Water distribution network

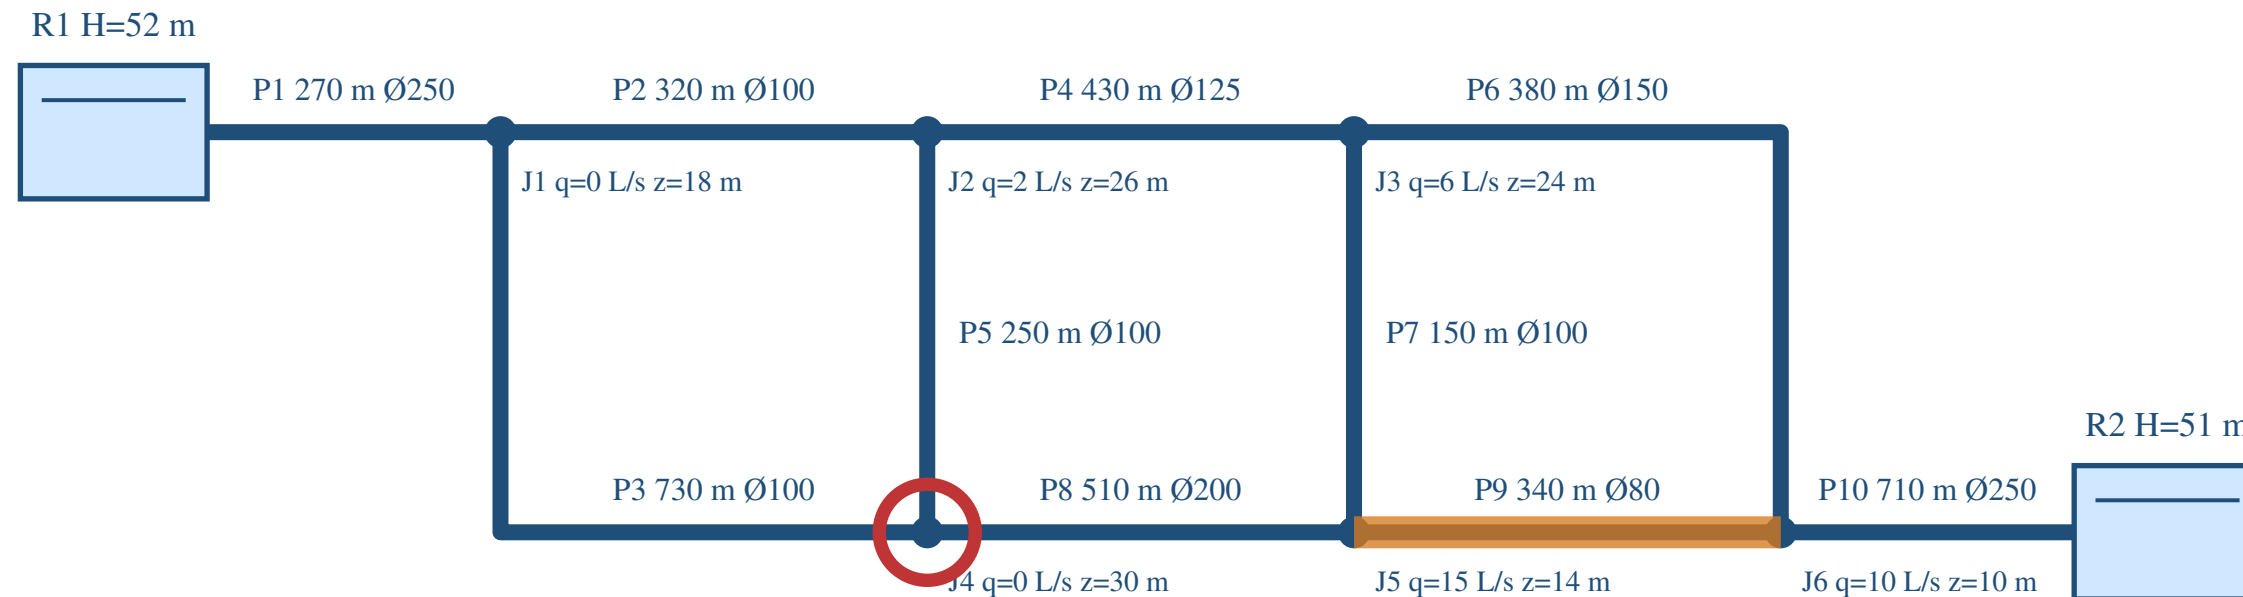
- **Astra edit: P9 290 to 340 m - drawing is correct**
Astra analysis: PASS; J4 = 20.04 m
- **Solve of returned SVG: FAIL; J4 = 19.23 m (min 20 m)**
